For: HEAT EXCHANGER WITH LEAKAGE VENT

RENEWED PETITION UNDER 37 CFR § 1.181

AMENDMENT

LETTER REQUESTING APPROVAL OF DRAWING CHANGES

FIG. 4

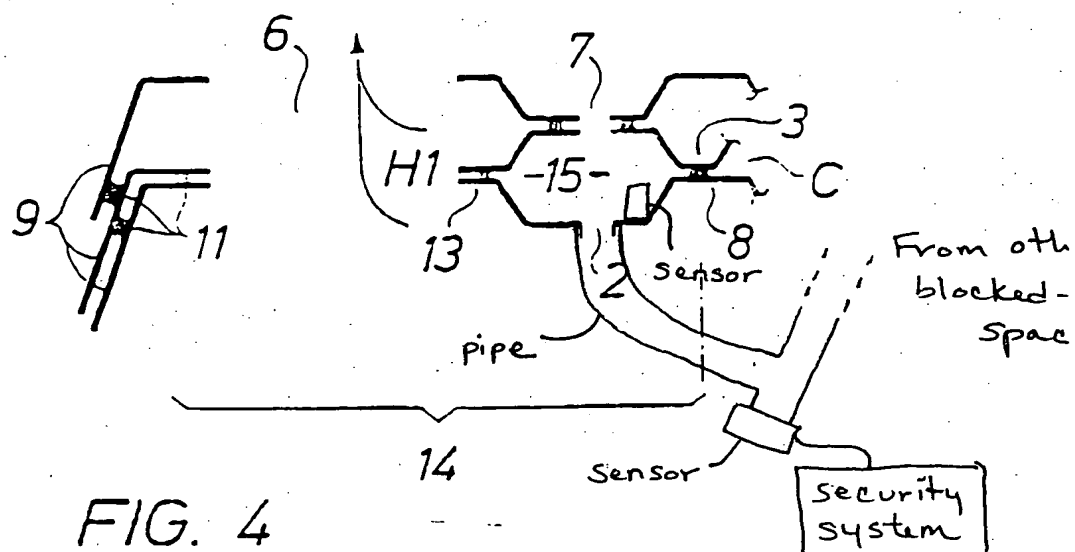
In the outstanding Office Action, the drawings were objected to as failing to comply with 37 C.F.R. 1.83(a), for not showing some claimed features, that is the pipes, a security system, and the sensors. Accordingly, the drawings have been amended to include those features. Hence, withdrawal of the 37 C.F.R. 1.83(a) objection is respectfully requested.

Please review for approval the proposed changes to the Formal Drawings shown in **RED** on the attached photocopy of Figure 4.
